REVISED SITE DEVELOPMENT PLAN - RETAIN EXISTING ANTENNA RANGE AND PARKING LOT FI

JOHNS HOPKINS APPLIED PHYSICS LAB NORTH PARKING / BALL FIELD ENTRANCE

REVISED SHEET INDEX AND ADDITIONAL NOTES

NO AS-BUILT ONTHIS SHEET SDP-04-66

SCALE
AS
SHOWN
SHEET
C1.3
SHEET 9 OF 84

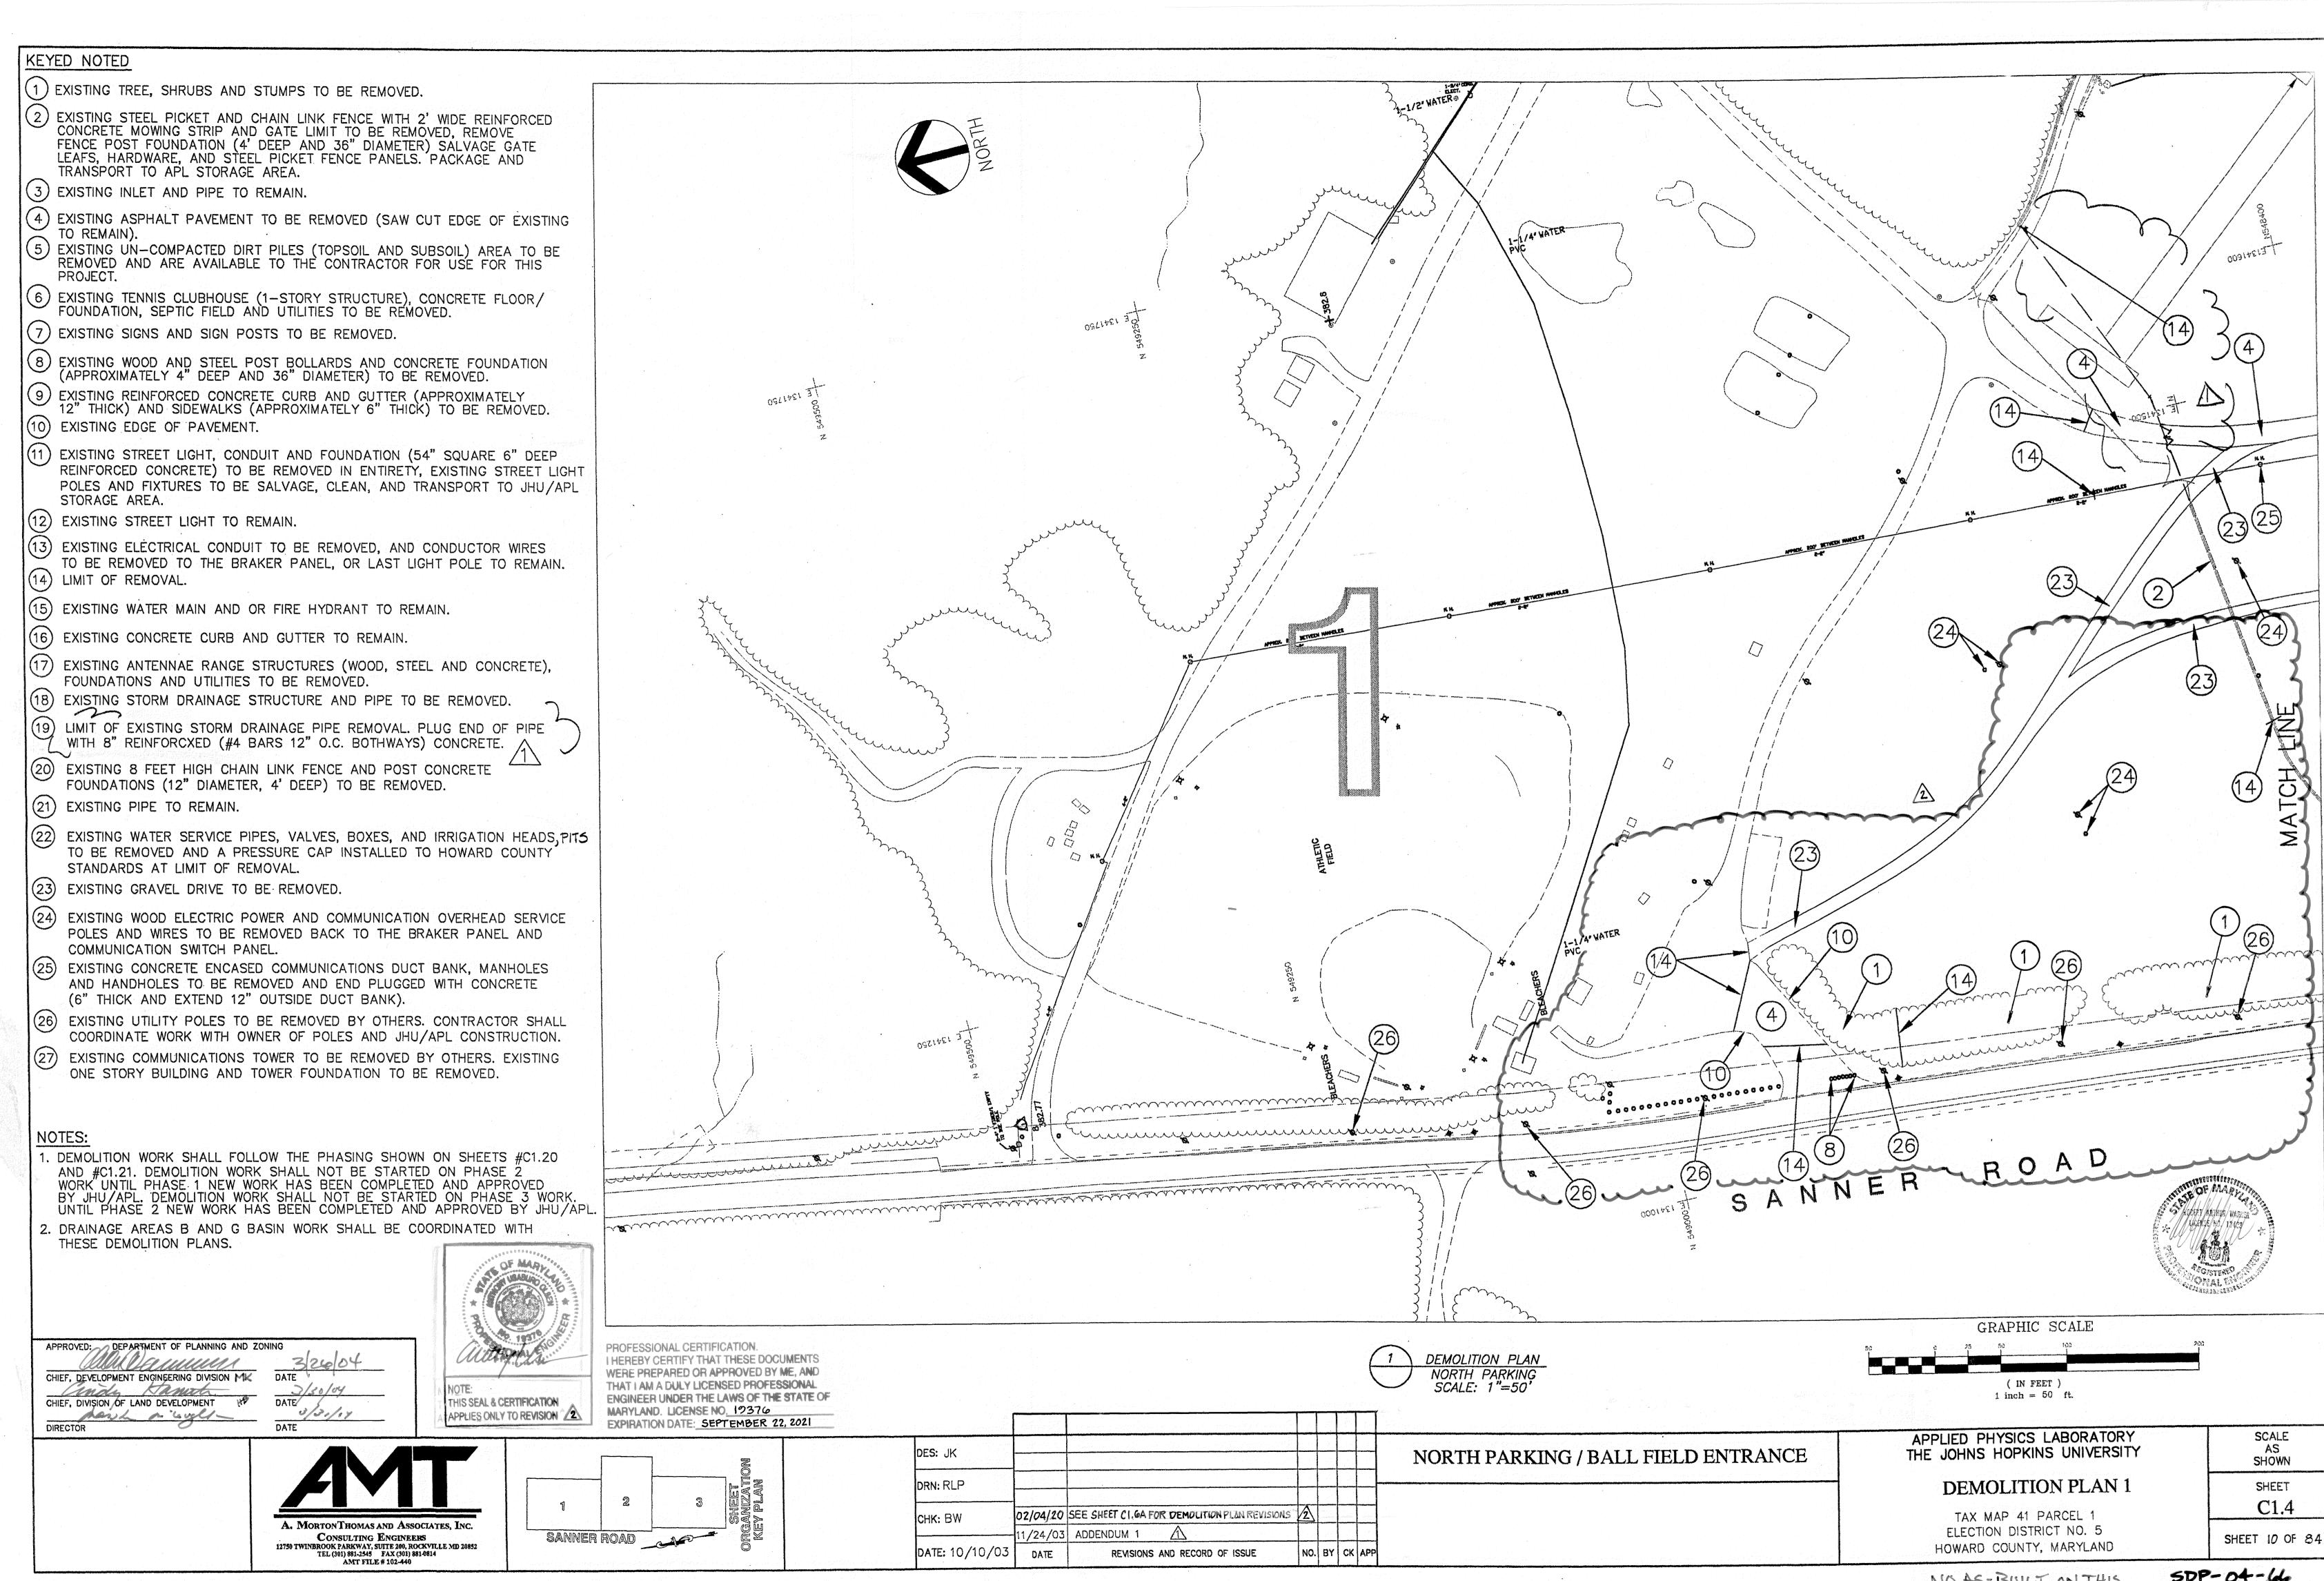
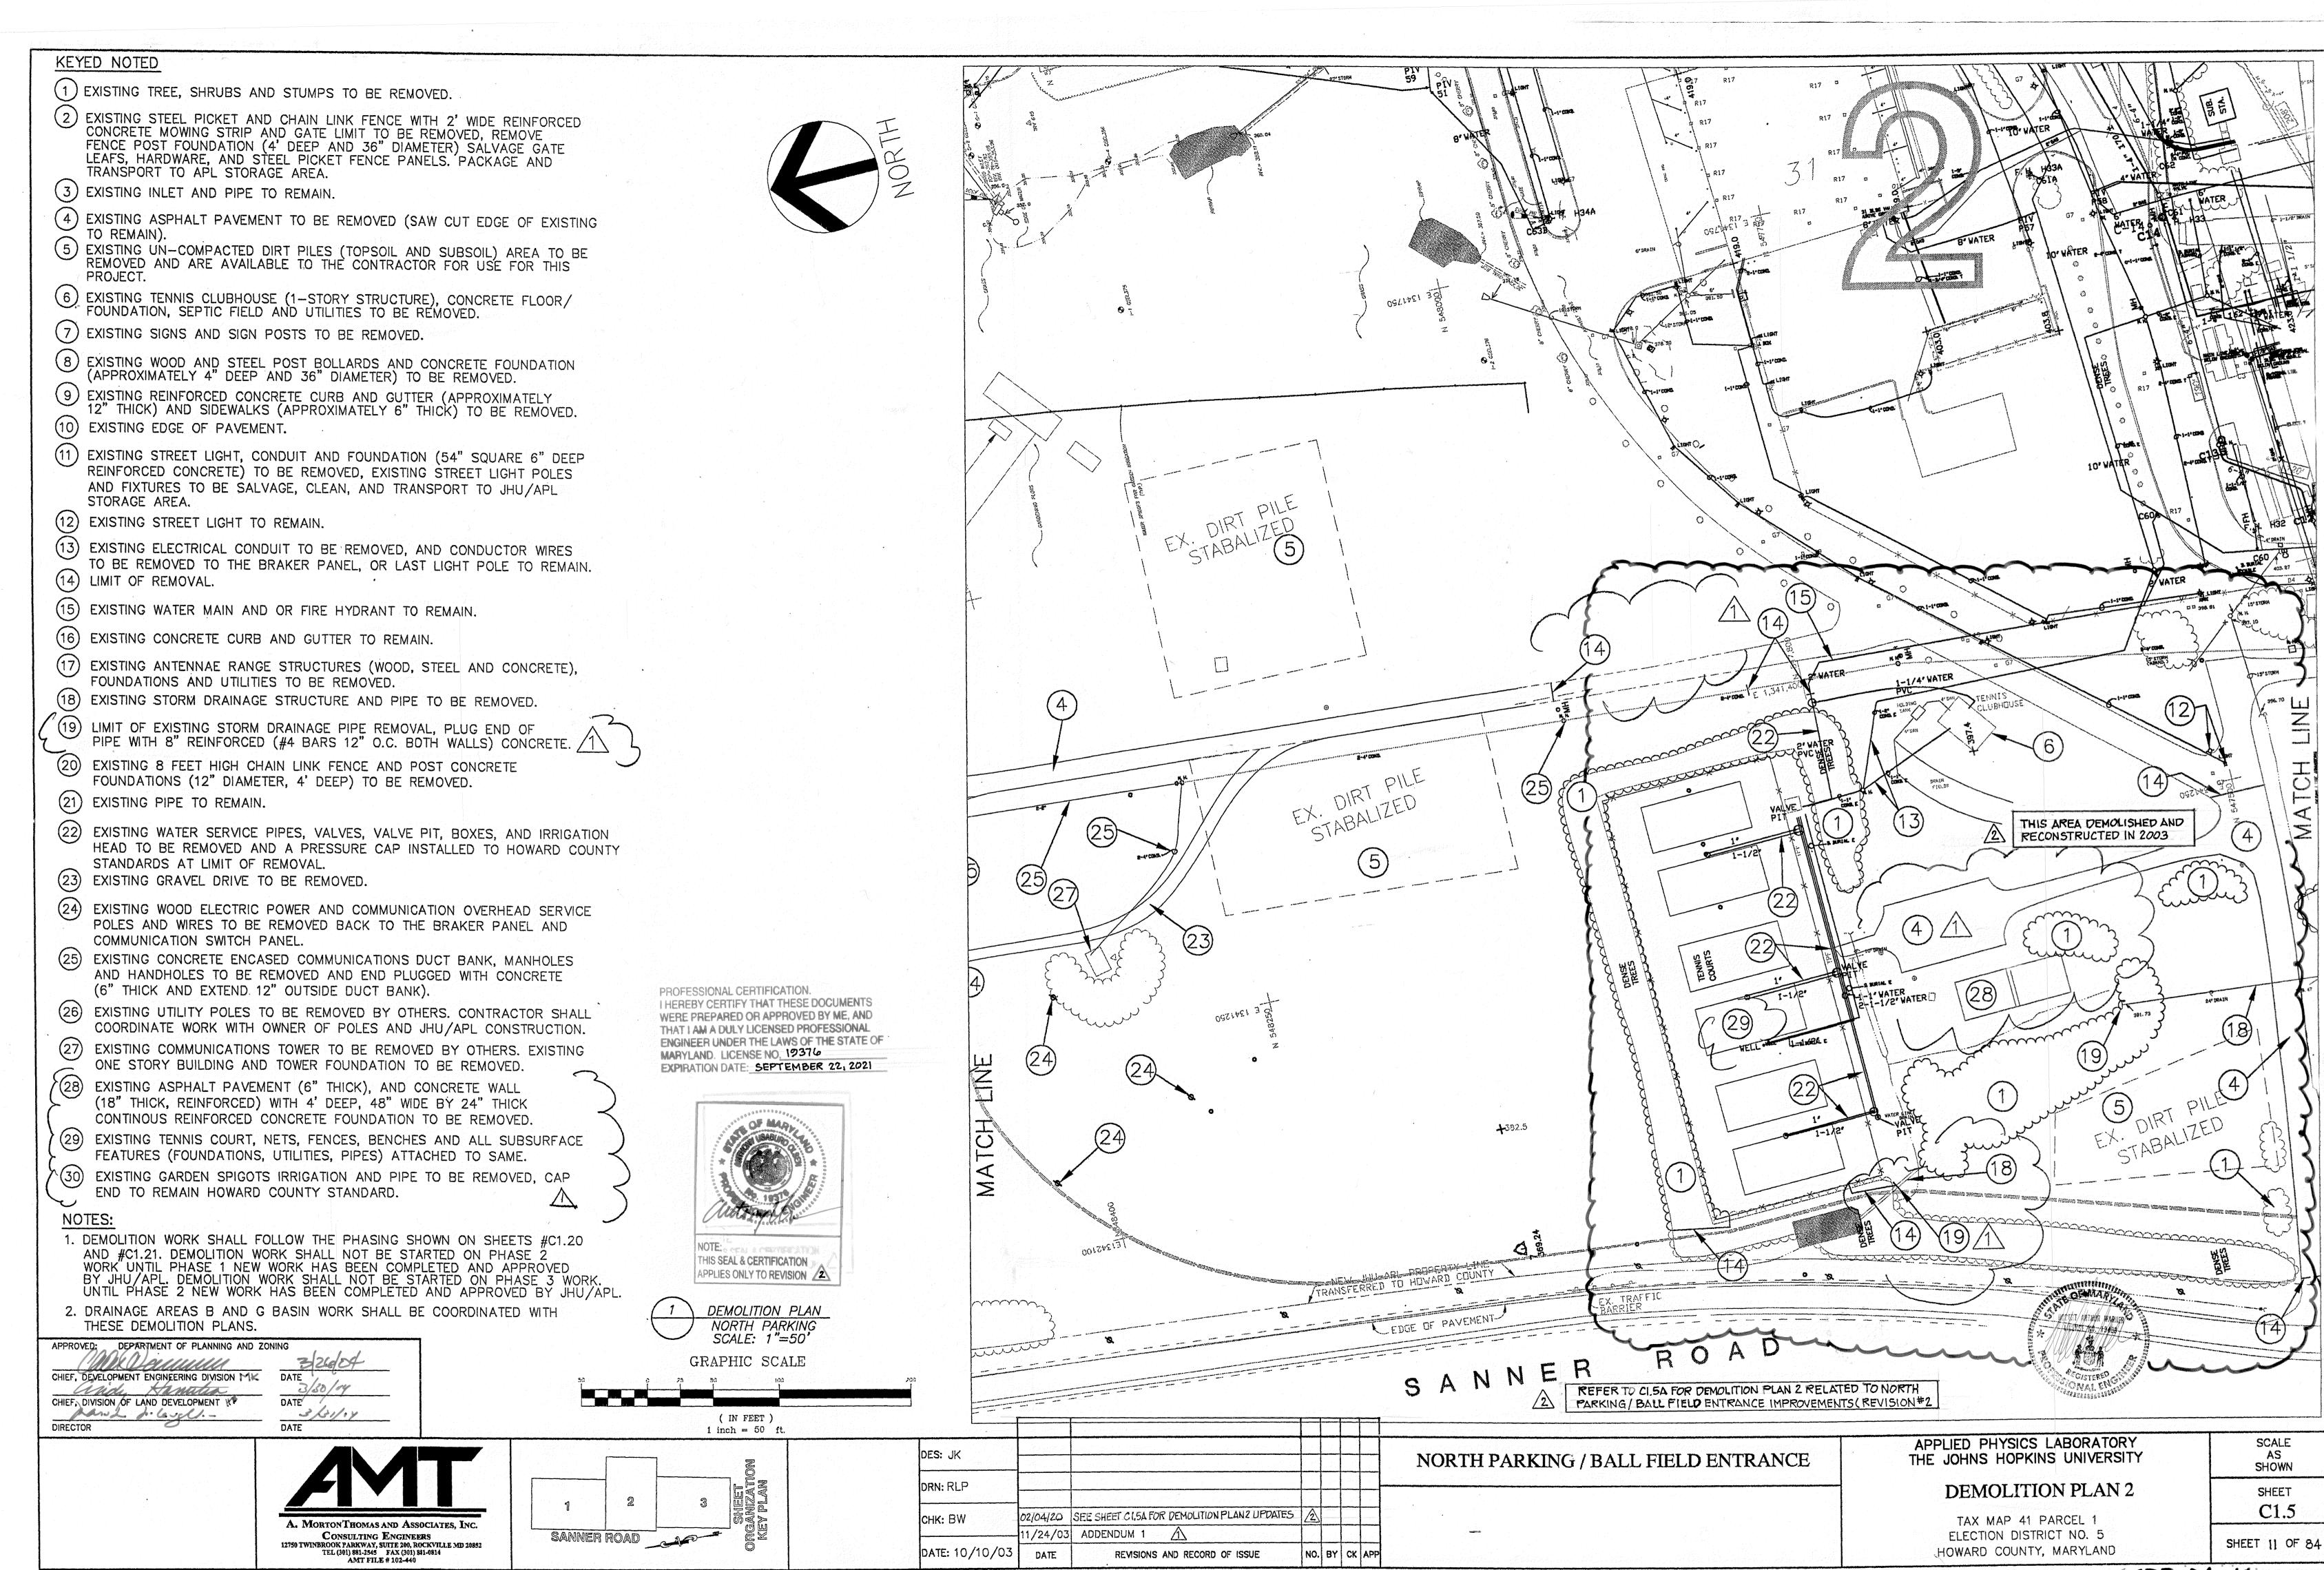
NOTE: REV 1 IS TO SHOW UPDATED DEMOLITION PLAN WITH ADDITIONAL REMOVAL OF PAVEMENT AND TREES DUE TO NEW PARKING FOR THE NORTH PARKING/ BALL FIELD ENTRANCE. SANNER ROAD KEYED NOTES: 1. REMOVE EXISTING TREE, SHRUBS AND STUMPS (TYP.) 2. SAWCUT AND REMOVE EXISTING ASPHALT PAVEMENT 3. SAWCUT AND REMOVE EXISTING CONCRETE CURB AND GUTTER THE TOPOGRAPHIC AND UTILITY INFORMATION SHOWN IN THIS DEVELOPMENT (APPROXIMATELY 12" THICK) PLAN WERE OBTAINED FROM LIDAR SURVEYS PERFORMED BY AXIS IN JULY 2014 FROM REPORTS PROVIDED BY JOHNS HOPKINS UNIVERSITY APPLIED PHYSICS LAB 4. LIMIT OF REMOVAL (JHU/APL). SINCE NOT ALL INFORMATION SHOWN MAY REFLECT CURRENT CONDITIONS, IT IS THE RESPONSIBILITY OF THE CONTRACTOR TO VERIFY CURRENT TOPOGRAPHIC AND UTILITY INFORMATION TO HIS OWN SATISFACTION. APPROVED: DEPARTMENT OF PLANNING AND ZONING 5.15.20 CHIEF, DEVELOPMENT ENGINEERING DIVISION CHIEF, DIVISION OF LAND DEVELOPMENT DIRECTOR 5-29-20 DATE PROFESSIONAL CERTIFICATION. I HEREBY CERTIFY THAT THESE DOCUMENTS WERE NOT FOR CONSTRUCTION PREPARED OR APPROVED BY ME, AND THAT I AM A DULY LICENSED PROFESSIONAL ENGINEER UNDER THE LAWS OF THE STATE OF MARYLAND, LICENSE NO. 19376 1 02/04/20 NEW SHEET - UPDATES TO DEMOLITION PLAN 2 EXPIRATION DATE: 09/22/2021 0 25' 50' 100'
